## FCC Class II Permissive Change Request Letter

RE: FCC Permissive II Change Request for Company: Suntech International Ltd. FCC ID: WA2ST600

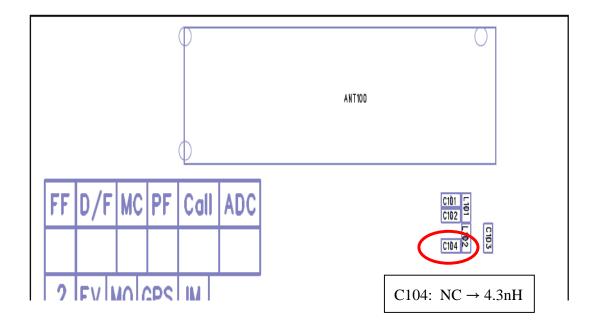
Original Antenna is on the PCB(Main Board). But, C2PC Antenna is seperate the PCB(Main Board). And, antenna matching value was changed(C104: NC -> 4.3nH).
